SUBJECT: WATERFORD STEAM ELECTRIC STATION, UNIT 3 – FLOOD FOCUSED
EVALUATION ASSESSMENT (CAC NO. MF9710; EPID L-2017-JLD-0009)

STAFF ASSESSMENT BY THE OFFICE OF NUCLEAR REACTOR REGULATION
RELATED TO THE FOCUSED EVALUATION FOR
WATERFORD STEAM ELECTRIC STATION, UNIT 3
AS A RESULT OF THE REEVALUATED FLOODING HAZARD NEAR-TERM TASK FORCE
RECOMMENDATION 2.1- FLOODING
CAC NO. MF9710

Figure 3.0-1 – General Layout of Waterford Site (adapted from Figure 3-3 of July 21, 2015, FHRR (ADAMS Accession No. ML15204A321))

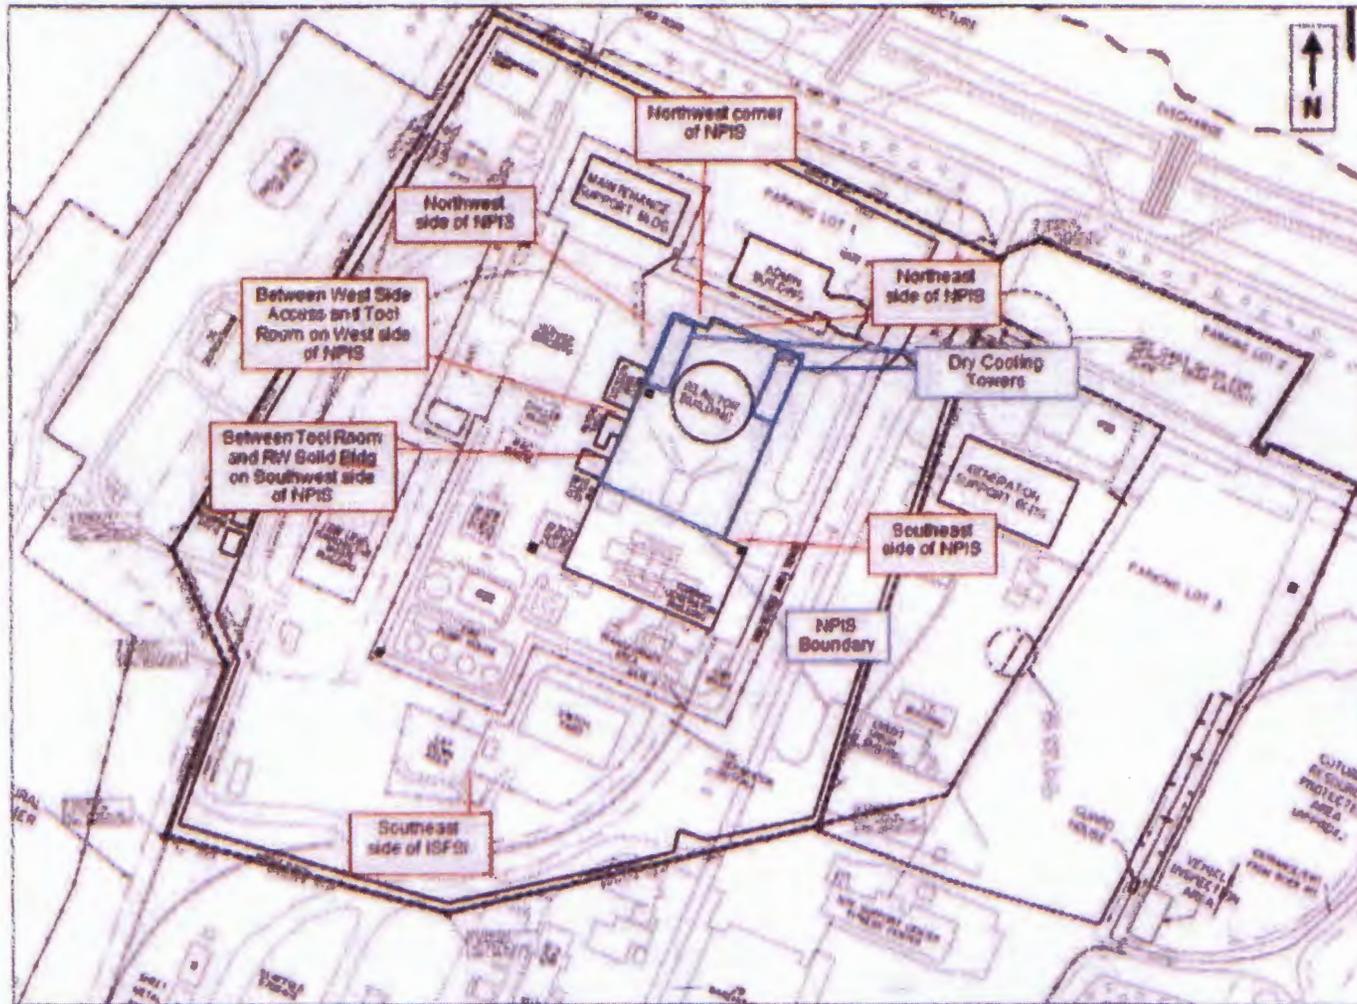
Per Waterford's CDB, the structures, systems and components (SSCs) important to safety are flood protected because they are enclosed in a rectangular box-like reinforced concrete structure 380 feet (ft.) long, 267 ft. wide, and extending 64.5 ft. below grade known as the nuclear plant island structure (NPIS). The NPIS is the common structure of the reactor containment building (RCB), reactor auxiliary building (RAB) and the Fuel Handling Building (FHB). All seismic Category I structures, safety-related systems and components are housed in the NPIS. All exterior doors and penetrations which lead to areas containing safety-related equipment are watertight up to 29.18 ft. mean sea level (MSL). Figure 3.0-1 of this document provides a general overview of the site including an outline of the NPIS.

Figure 3.0-2 Overview of the Location of the "B" Wet and Dry Cooling Towers

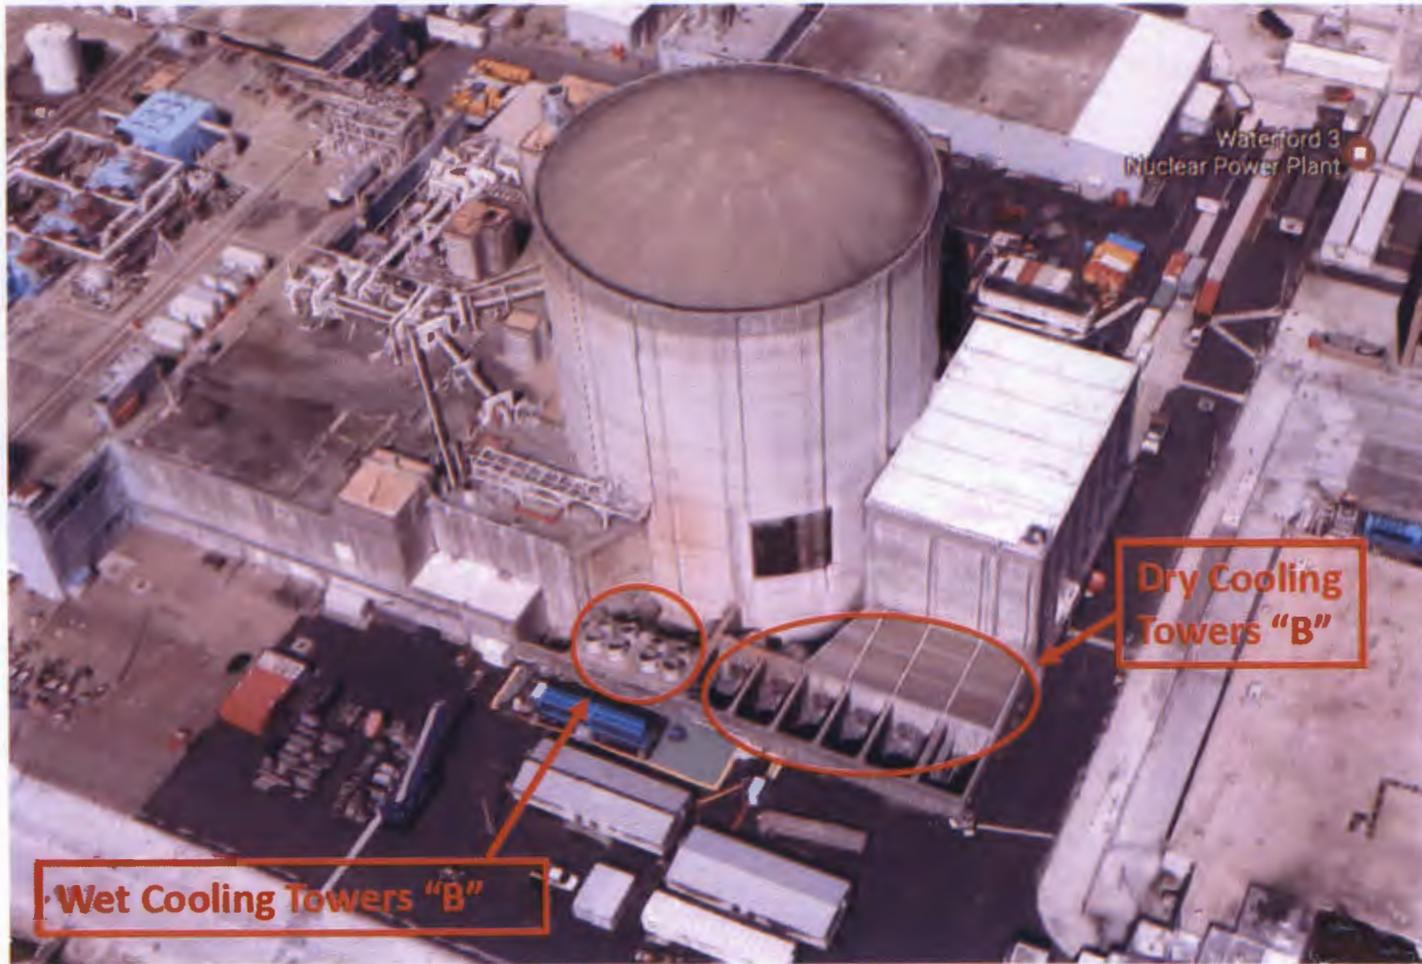
The auxiliary component cooling water system (ACCWS) removes heat, if required, from the CCWS via the component cooling water heat exchangers and dissipates it to the atmosphere. The ACCWS consists of two independent loops which include two CCWS heat exchangers (shell side); two full-capacity pumps; two wet type, mechanical draft cooling towers; and two cooling tower basins, each of which stores sufficient water to complete a safe shutdown based upon a loss of coolant accident and minimum safeguards operation. Figure 3.0-2 of this document provides an overview of the location of the "B" wet and dry cooling towers, which are both located within the NPIS.

Figure 3.2-1 – Location of the Bonnet Carre Spillway and Floodway in Relation to the Waterford Site (adapted from Figure 3-23 of the July 21, 2015, FHRR (ADAMS Accession No. ML15204A321))

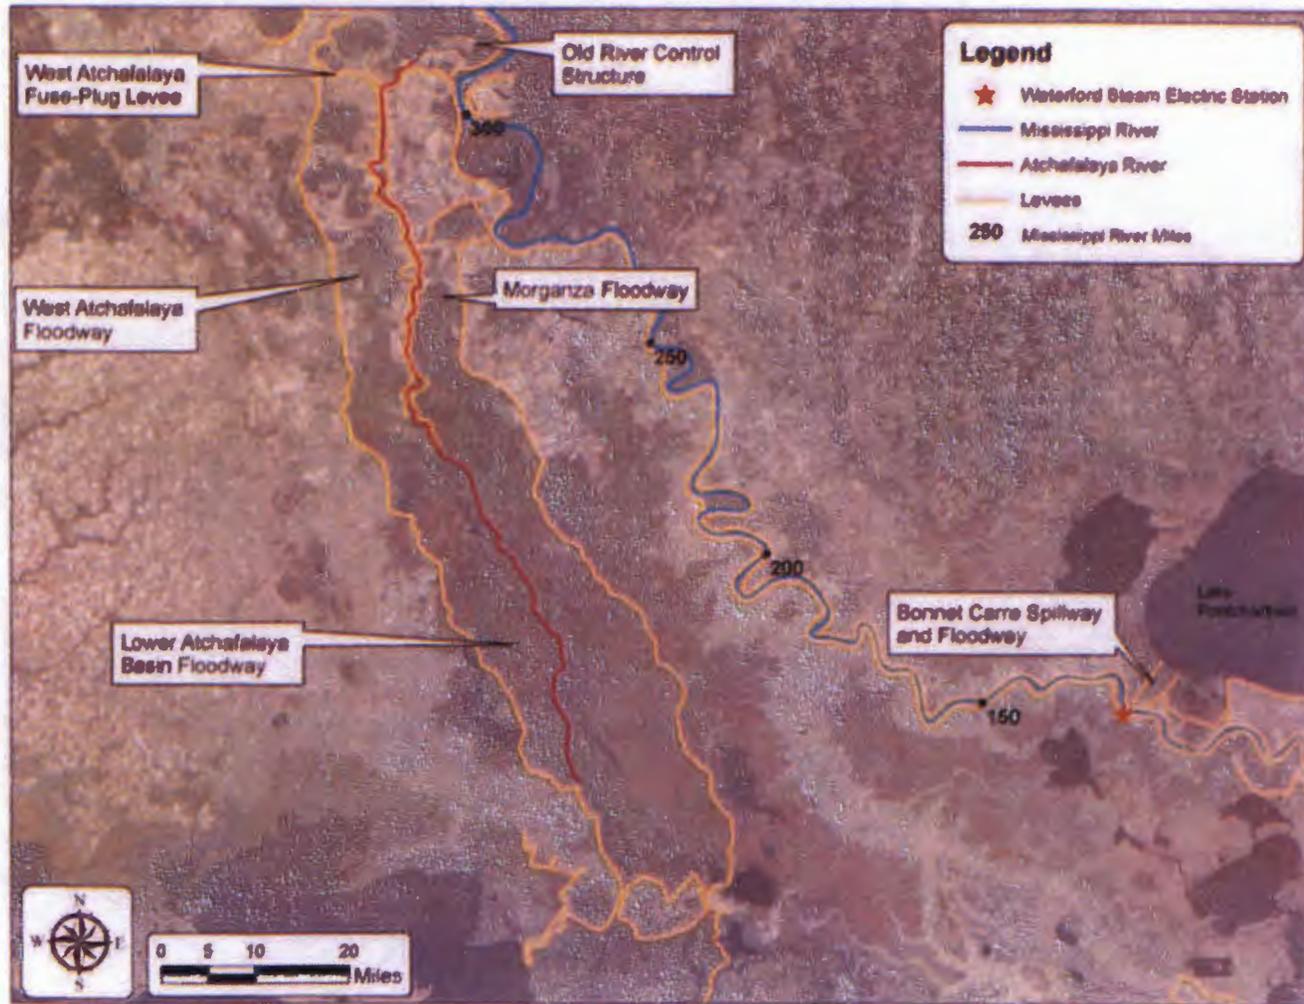
- As described in Section 3.2.2 of its FHRR, the licensee's evaluation did not credit the Bonnett Carre Spillway and Floodway that could be used to divert flow from the Mississippi River to Lake Pontchartrain) was not modeled. Figure 3.2-1 shows the location of this spillway in relation to Waterford. Allowing water to be diverted via this spillway to Lake Pontchartrain would lower the PMF water surface elevation at Waterford. The staff agrees with the licensee's assertion that it is a conservative assumption to not model this spillway.
